Objections to Priests Lane Development Plans

Neighbourhood Residents
Association

This document has been prepared by the Priests Lane Neighbourhood Residents Association to highlight the residents' strong objections to the proposal to develop the land at the rear of Priests Lane as set out in the Draft Local Development Plan (sites 044 and 178).

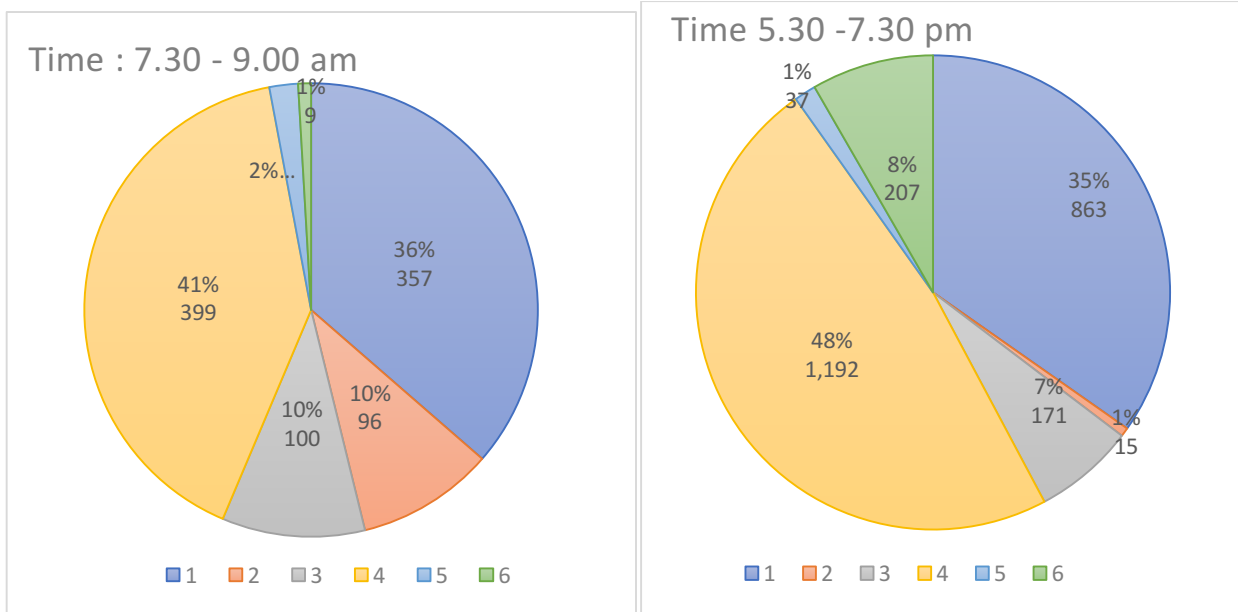
The following charts show the traffic movements around the Priests Lane/Glanthams Road junction, recorded 16 March 2017.

This data demonstrates that a significant number of vehicles and a large proportion of the traffic movements along Priests Lane use this junction. The proportions of traffic movements can be illustrated in the diagrams below.

A large-scale development with an access road at 61a Priests Lane would create a significant increase in traffic movements at an already busy and low visibility junction. We consider that this would have a considerable and detrimental effect on safety.
